AGENDA FOR REGULAR MEETING VILLAGE OF TINLEY PARK PLAN COMMISSION

SOUTHWEST CHICAGO CHRISTIAN SCHOOLS- 17171 84TH AVENUE PUBLIC HEARING: VARIATIONS AND SITE PLAN REVIEW

PLAN COMMISSION STAFF REPORT- Workshop

Site Plan Approval,
Variations

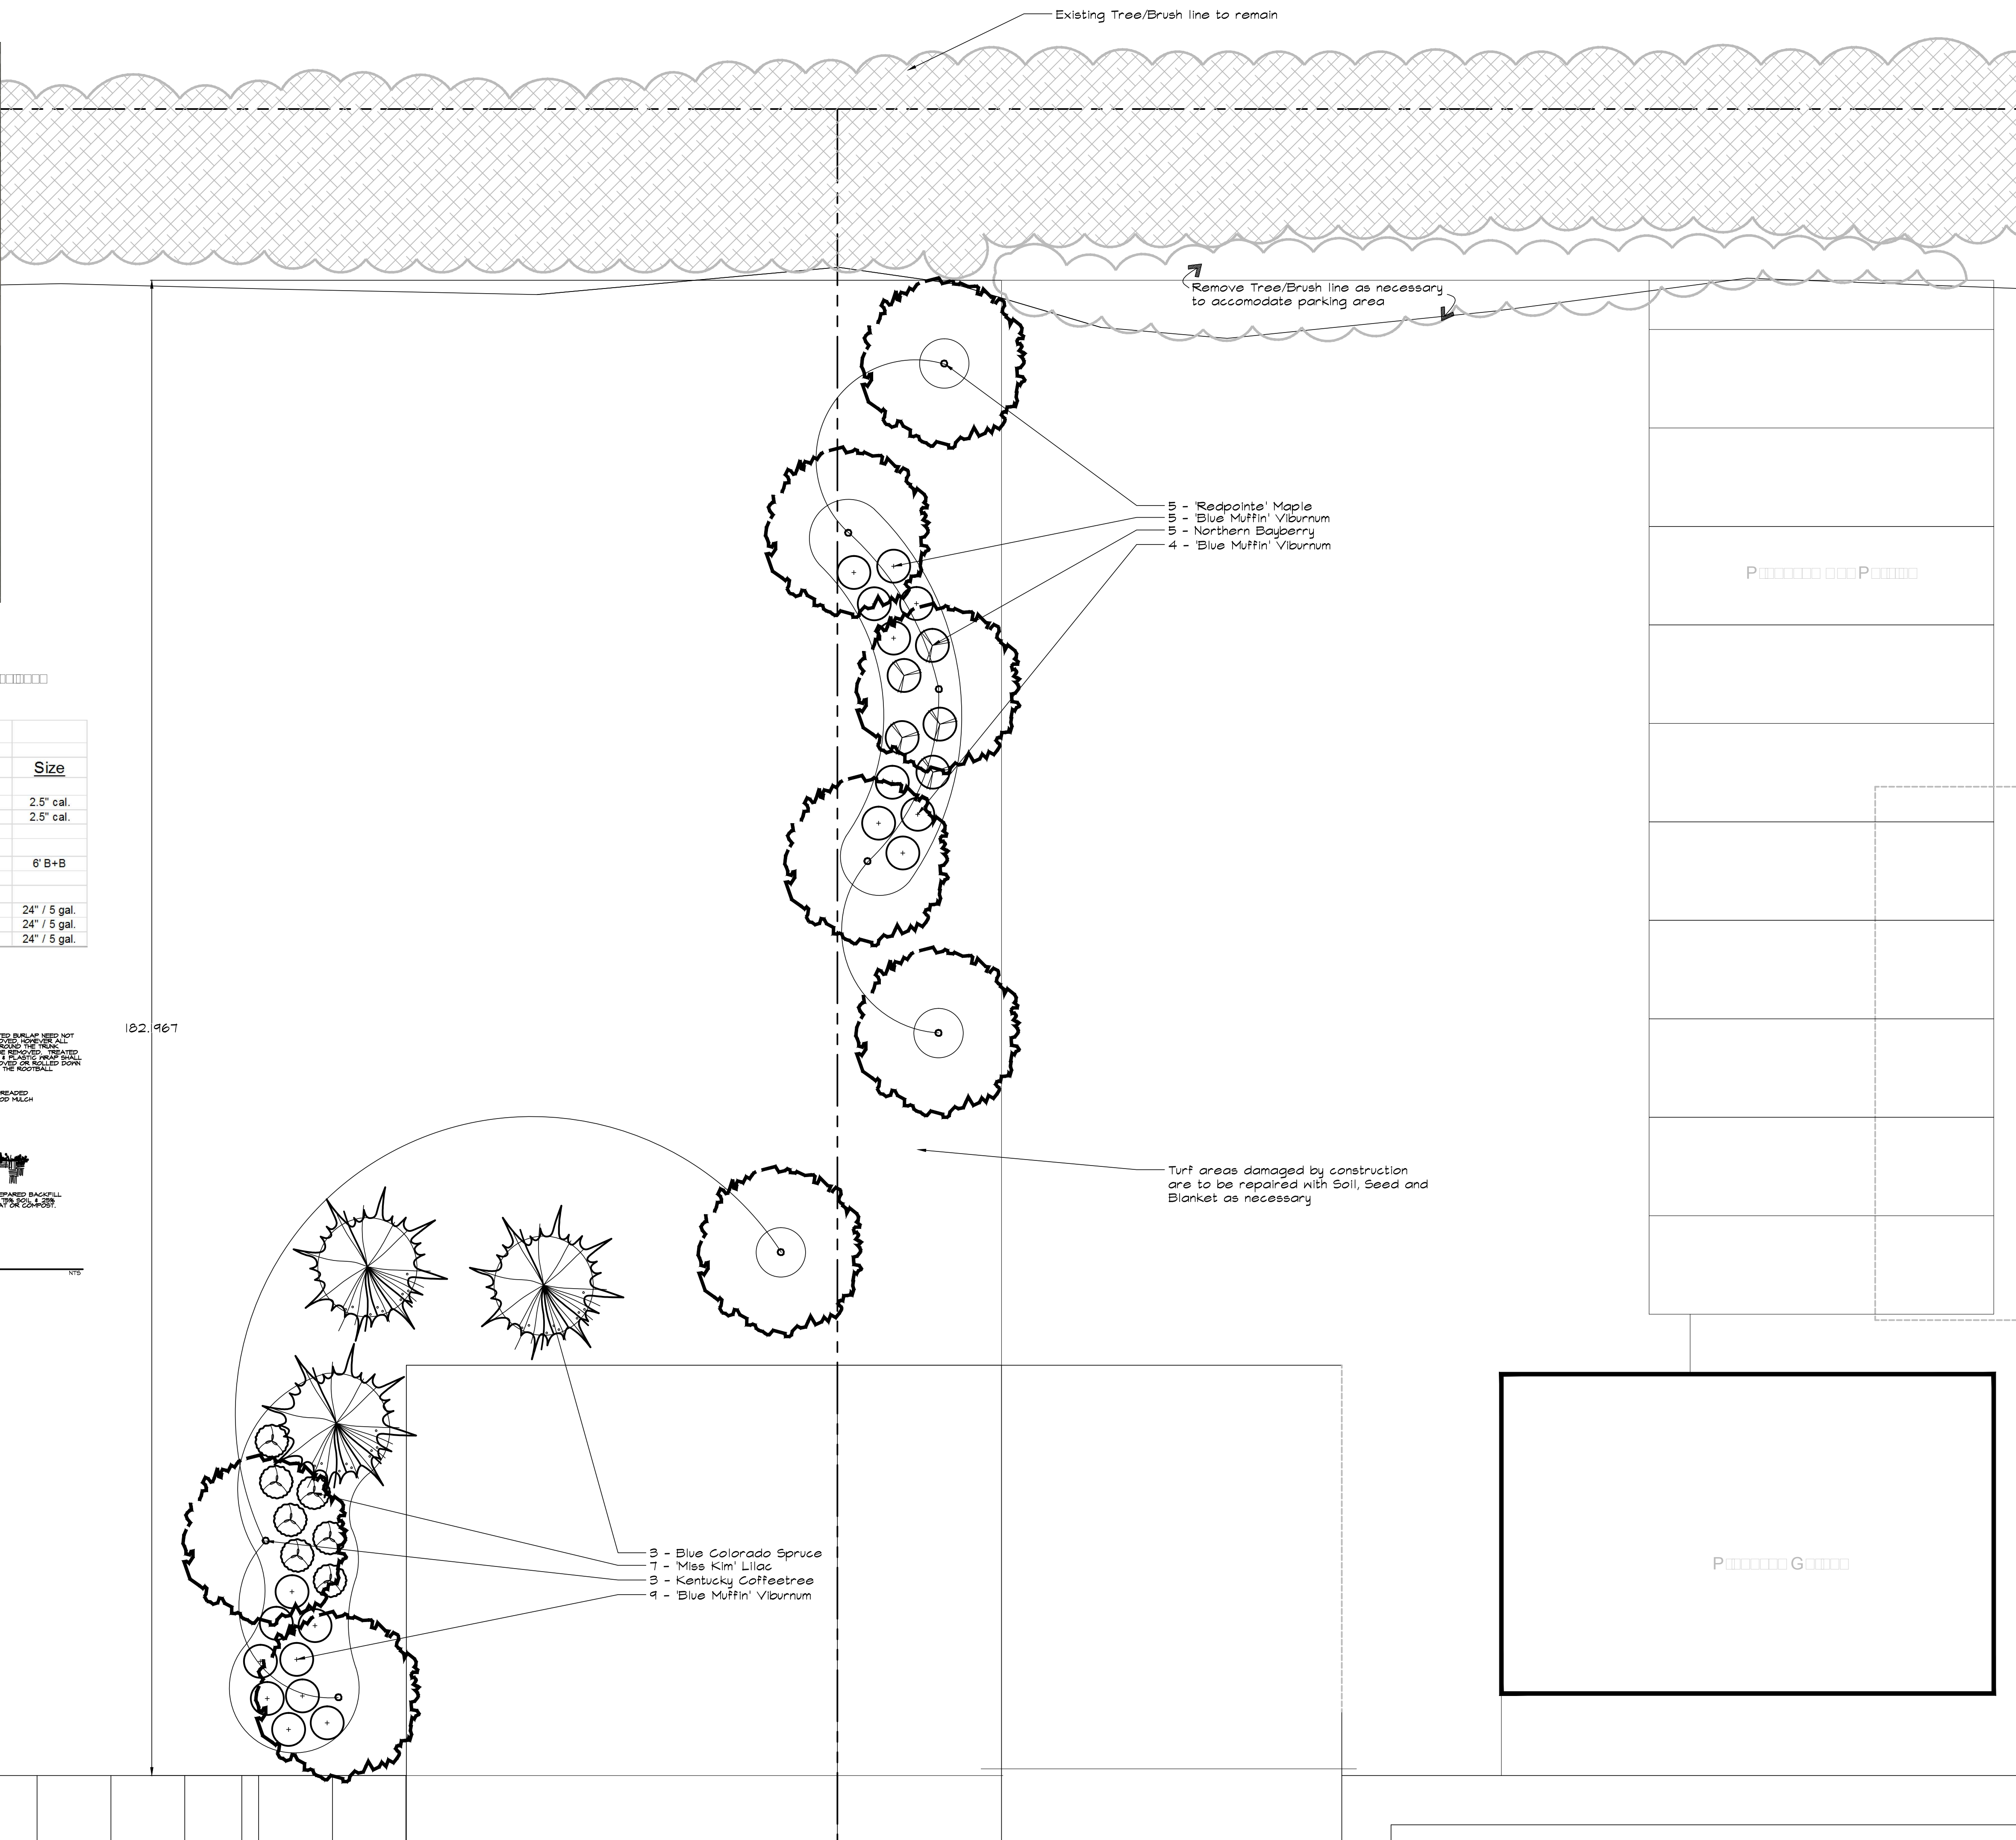
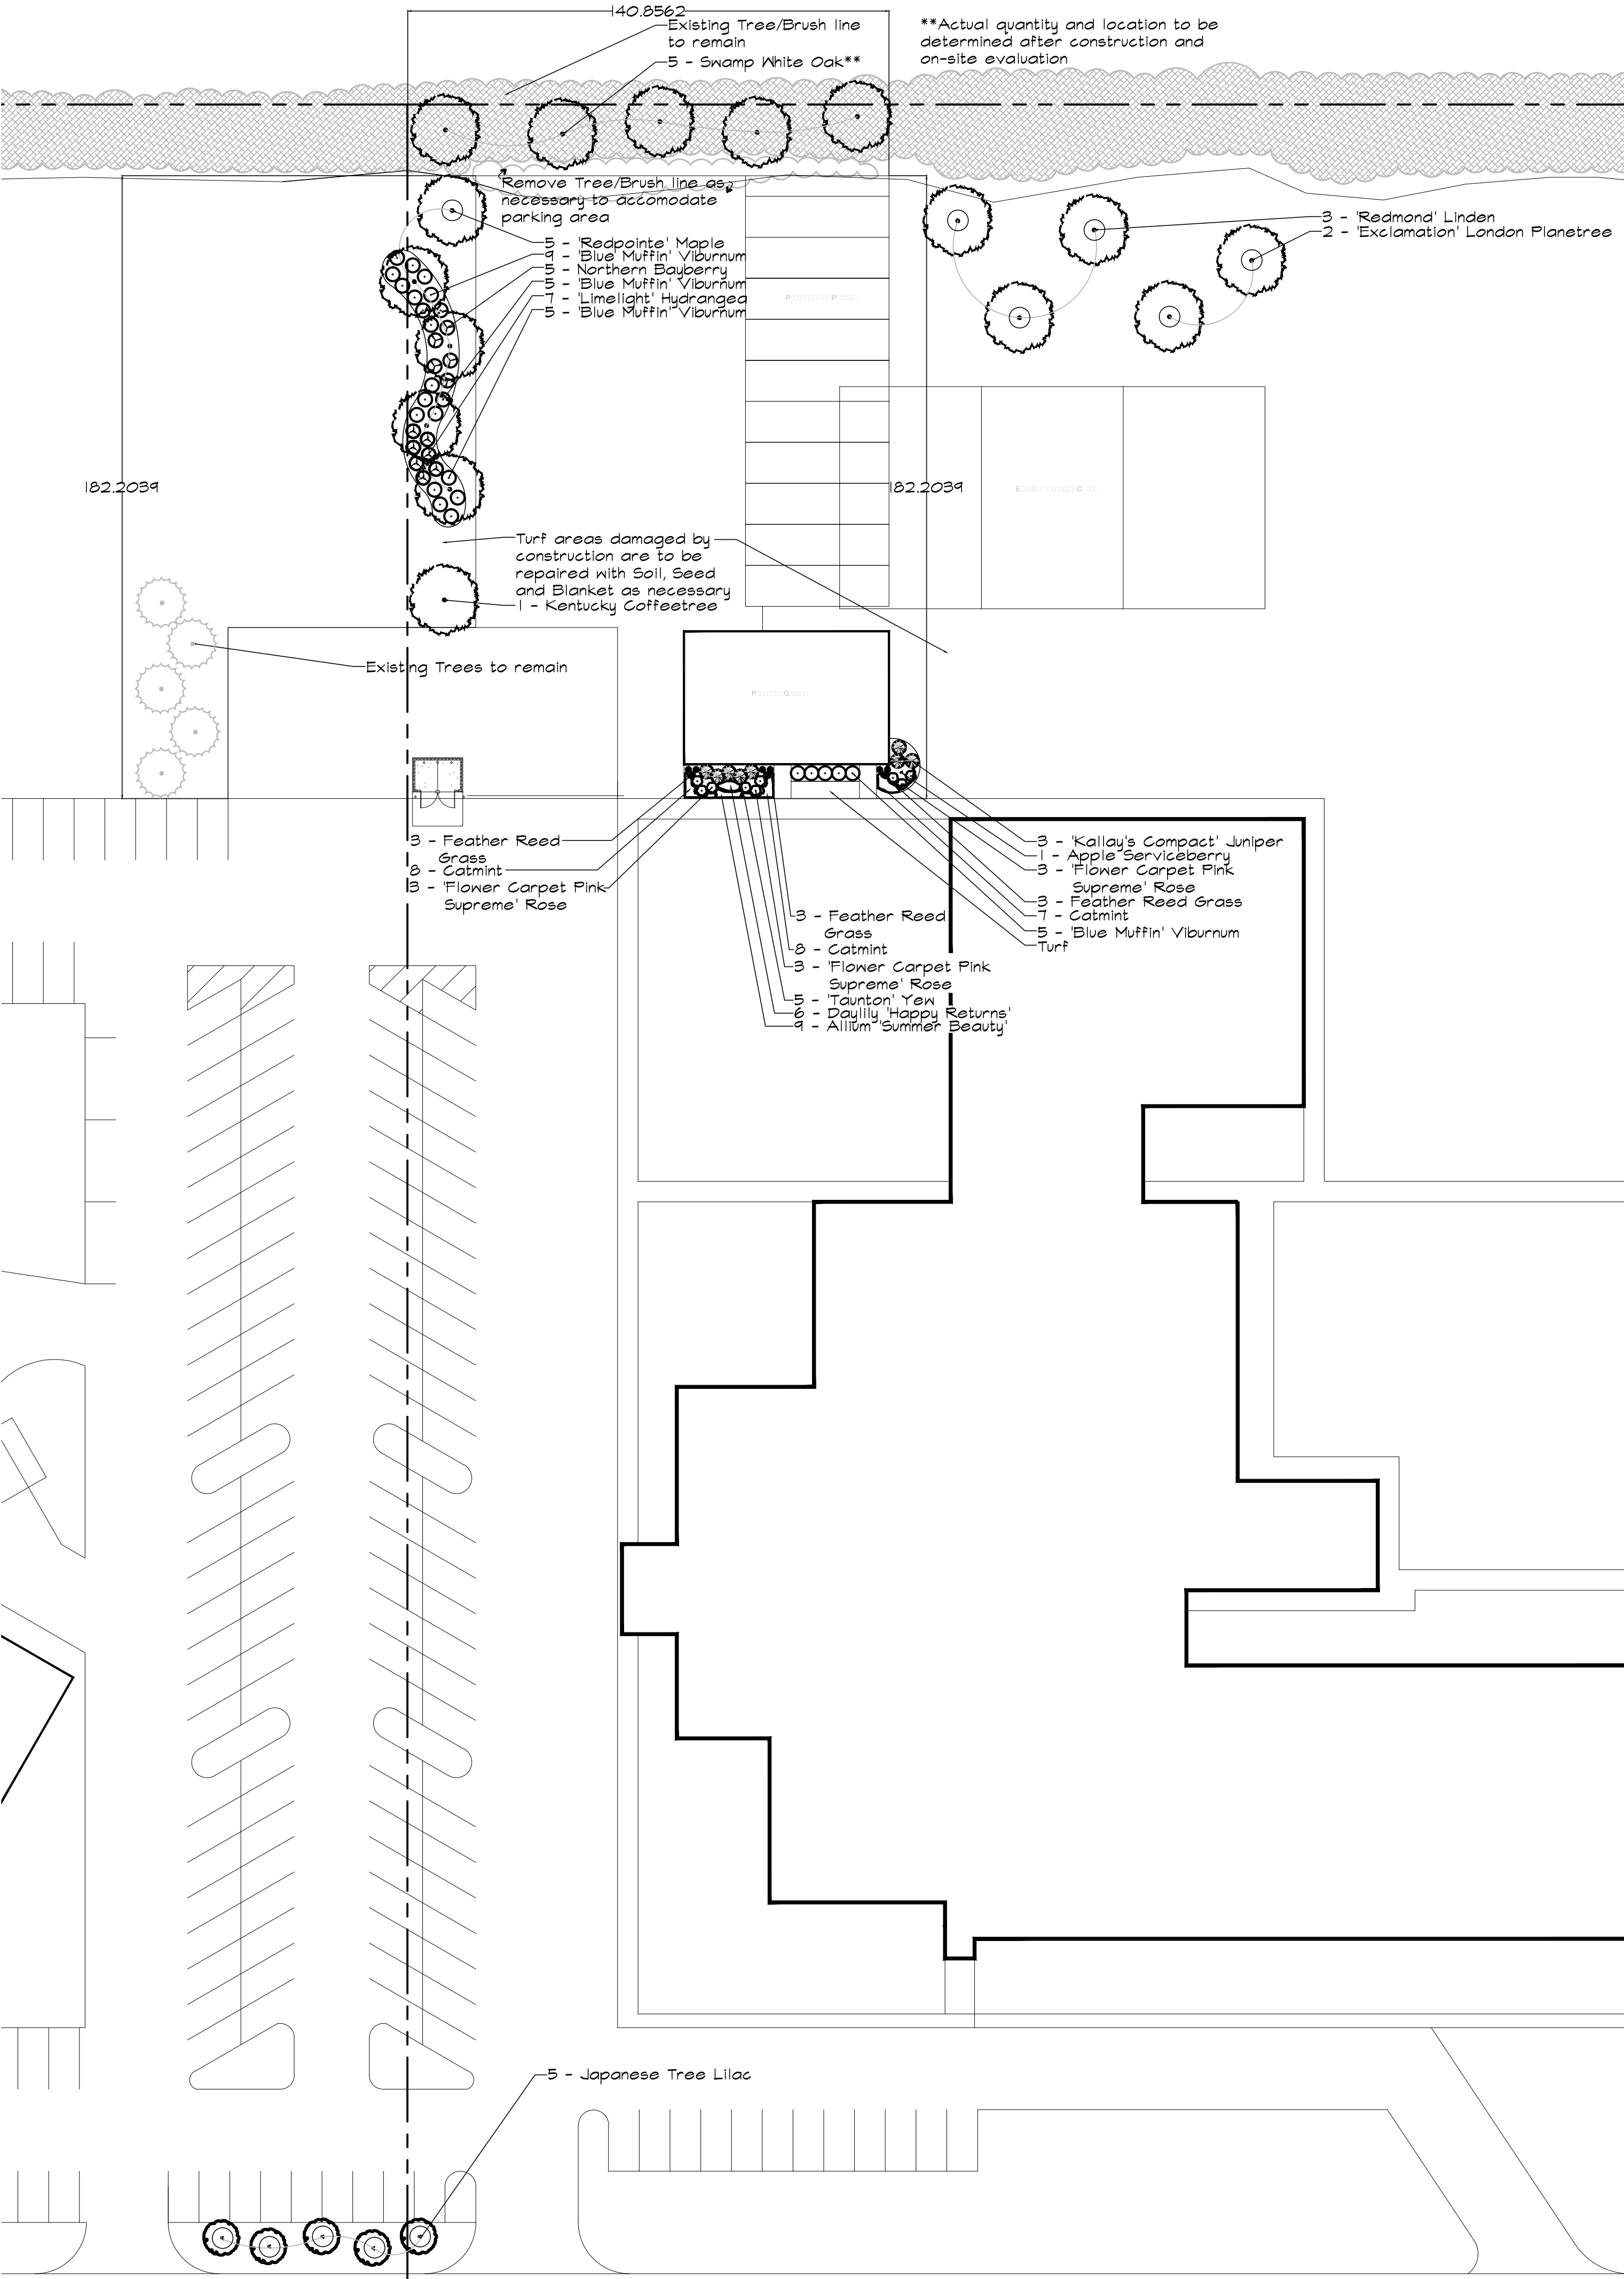
- South – due to the large stand of existing vegetation on the south property line, and the distance from the special use to the south property line (~900'), these buffer plantings could be scaled back without visually detracting from the campus. It is recommended that only the canopy tree plantings be installed. This is reflected in the table below.
- East – the landscape plan recommends “remove tree/brush line as necessary to accommodate parking area.” To ensure some buffer exists, it is recommended that only the canopy tree plantings be installed. This is reflected in the table below.

2. Section 158.20.1(b) of the Municipal Code requires all parking to be screened from the view of adjacent properties and streets by plantings, berming or low fence/wall. This has not been shown on the landscape plan. If bufferyard plantings are installed as recommended above, this requirement

3. Section 158.20.1(i) of the Municipal Code requires at least 15% of the parking lot shall be covered by landscaping. This has not been shown on the landscape plan. Given the use (bus parking), requiring islands to achieve this 15% could potentially be avoided.

4. Section 158.14.10 of the Municipal Code requires a 10' wide landscape area to front 70% of the side of all buildings which front dedicated streets (in this case, the north building elevation). This has not been shown on the landscape plan. Given that this façade has a vehicular service door, a pedestrian doorway, and this façade is significantly setback from 171st Street (~500'), requiring these plantings could potentially be avoided.

Applicant’s response: *The landscape design has been revised to show the **canopy trees on the south**. The feasibility of **adding trees to the east** may need to be verified at the time of construction. The School is not opposed to adding trees, but does not want to commit to cutting down existing trees in order to plant new trees. We would propose coordinating the final planting with the Village once we see what is left and the condition of the existing landscape screen after parking lot installation.*

Applicant's response: *The School is not opposed to adding landscaping as part of this project, however 1 and 1/2 of the parking islands noted to be improved are on the Church property not the School. The School can approach the Church to see if they desire this improvement or would allow it, however the outcome of that is unknown. From a functional standpoint not having a curb on these islands does allow for more flexibility with bus maneuvering. We would propose adding some planting equal to the amount that would go in the suggested islands along the 82th Ave. parkway instead. (Circled in Green above).*

Applicant's response: *We would agree this is not desirable; this is a bus parking area not a typical parking lot open to the public.*

Applicant's response: *The landscape plan has been revised to show some low planting along the west elevation of the building. We feel this will help integrate the building into the campus and help to address the concerns raised by Planning regarding the architectural interest of this elevation.*

Staff has reviewed the revised landscape plan and finds it addresses the deficiencies of the first submittal and meets the intent of the Landscape Ordinance. Staff recommends making any final approval of the Site Plan on Staff's field inspection after construction.
